FIELD INSPECTION

Project Name:	Mountain Valley Pipeline	Inspector:	Matthew Grant
Inspection Date:	Tuesday, December 18, 2018	Project Contact:	Brian Clauto
Spread: Pittsylvania County MP 299-MP285 Transco	Spread I	Weather (Wet/Dry/Rain):	Wet

FIELD INSPECTION PHOTO LOG

- Fig. 1 Sediment basin riser requires maintenance and re install at Transco site.

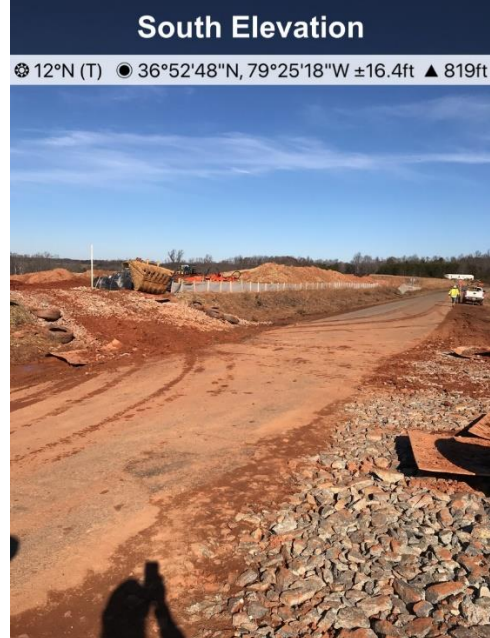
- Transco sediment basin riser requires maintenance and re install.
- St#15693+80 construction entrance at Riddle Rd requires maintenance.
- St#15700+00 designated stream SB-6 requires sediment removal.
- St#15080+00 plunge pool is discharging onto the ROW.

Recommended Corrective Action: The issues noted above were added to the daily punch list on 12/18/18. Repair and maintain all controls per the approved plan, and remove sediment per DEQ approval.
